### STAFF REPORT

#### Application for Willamette River Greenway Review Construction of an Addition to an Existing House

FILE: WG-01-16

ADDRESS/LOCATION: 325 Sherman Street NE

EXHIBIT MAP  
 WILLAMETTE GREENWAY SETBACK  
 FOR  
**BOB NELSON**  
 LOCATED AT  
 325 SHERMAN STREET  
 ALBANY, OREGON 97322  
 OCTOBER 3, 2016

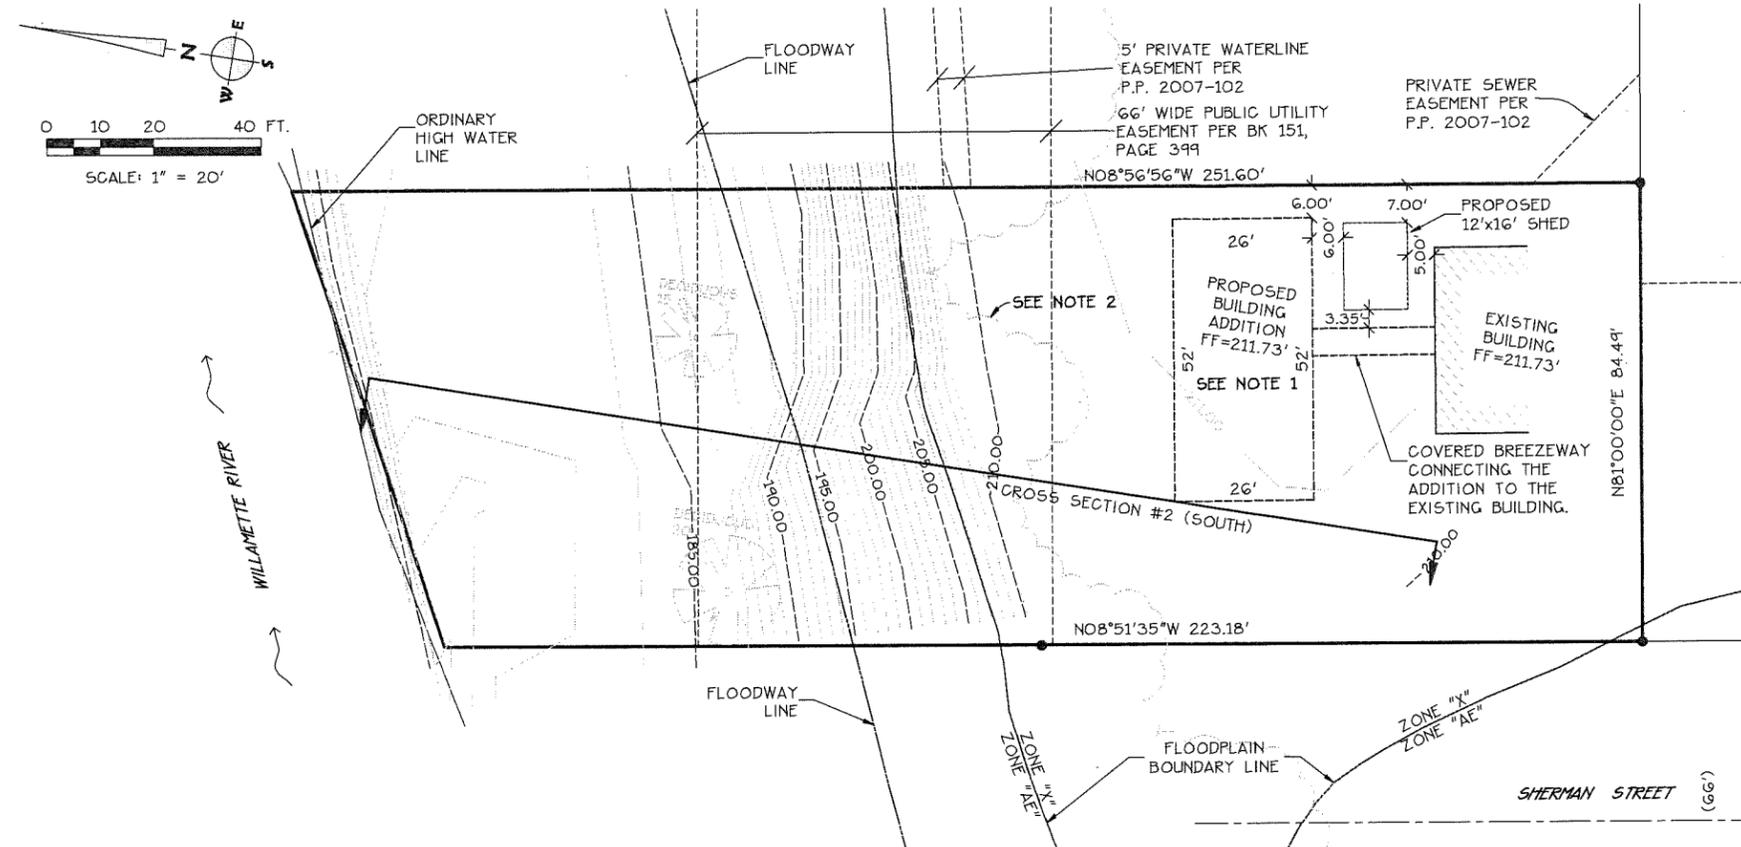
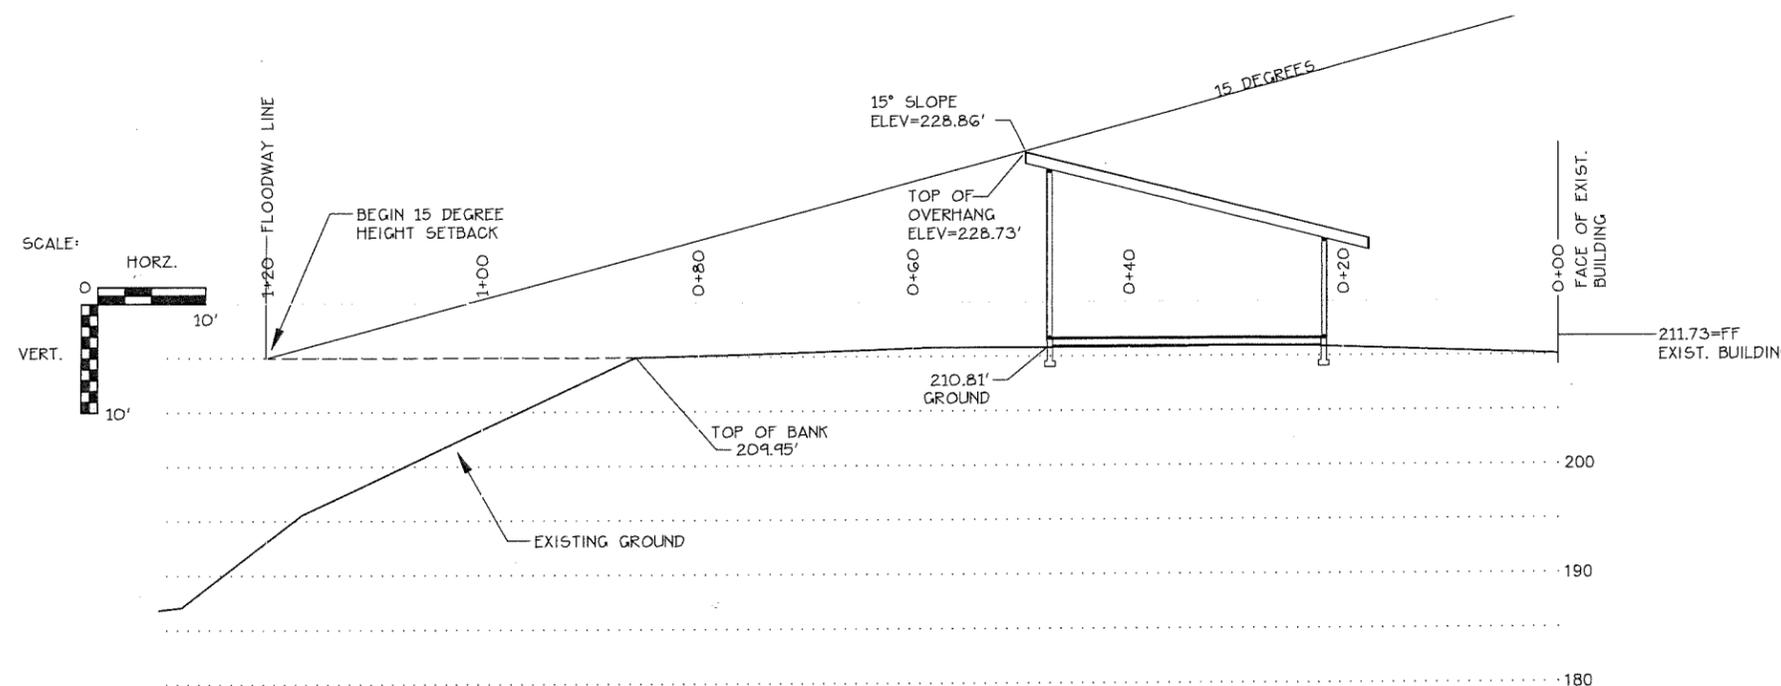
The natural vegetative fringe runs along the top of the bank as shown on the site plan. The proposed addition is 35 to 45 feet from the top of bank. The proposed addition is located in what is currently the back yard of the existing house. The proposed addition will not affect the natural vegetative fringe. This criterion is met.

The proposed addition to an existing single-family home is not a water-related or water-dependent use. As presented in the site plan (Attachment B), the proposed addition is not in the floodway or the 100 year floodplain. The structure is proposed to be 35 to 45 feet from the top of bank. Based on a site survey, the existing ground elevation of the proposed building will be seven feet above the 100 year base flood elevation. As shown on the design drawing (Attachment B), the proposed structure is setback south of the Willamette River such that the structure height is within a 15 degree height envelope from the floodway boundary, and the peak of the roof will be 17 feet above the finish floor. This criterion is met.
